Technical Service Bulletin

Subject: CHECK ENGINE LIGHT ON WITH P0451:00 IN COLD WEATHER	Bulletin No.: 01-003/17
	Last Issued: 03/29/2017

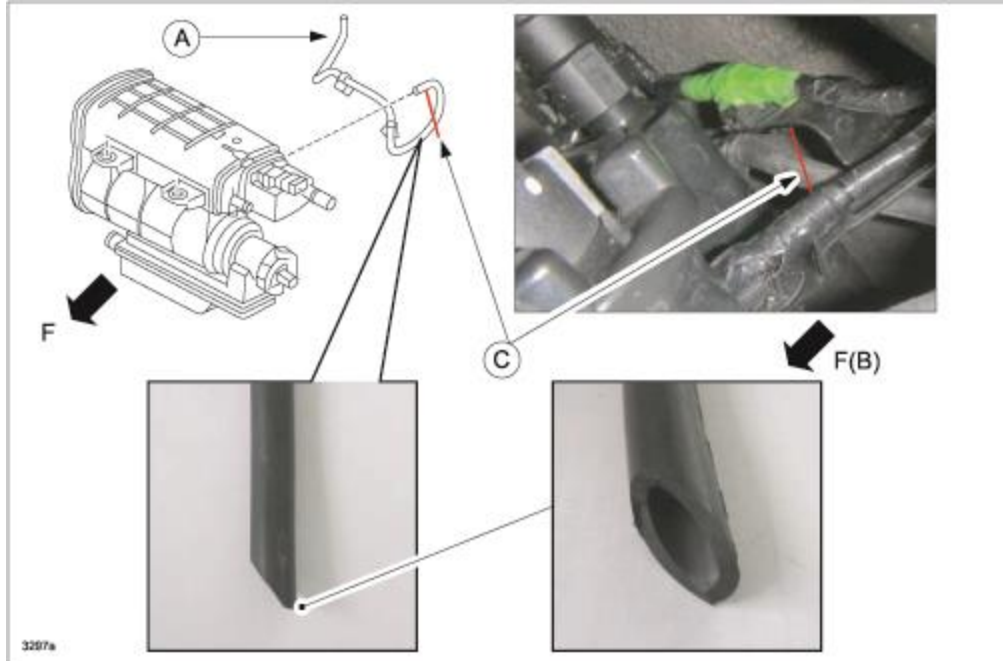
When the engine is started for the first time after parking overnight in cold weather (below freezing), some vehicles may exhibit the check engine light on with DTC P0451:00 (Fuel tank pressure sensor: sensor characteristic malfunction) stored in memory. This concern may be caused by an increase in discharge resistance due to water accumulated and frozen in the canister vent hose.

1. Verify the customer concern.
2. Safely lift the vehicle up on a hoist.
3. Check if the Canister Vent Hose is clogged with frozen water.
 - If the hose is clogged with frozen water, go to the next step.
 - If the hose is not clogged with frozen water, refer to MS3 online instructions to diagnose DTC P0451:00.

a. Cut the Evaporative Hose No.1 (A) diagonally to enlarge the cross section as shown (C = cut point) to avoid water from accumulating and freezing. (F = vehicle front, F(B) = Vehicle front (view from bottom))

NOTE: Use of a utility knife or pliers with cutters is recommended to cut the hose.
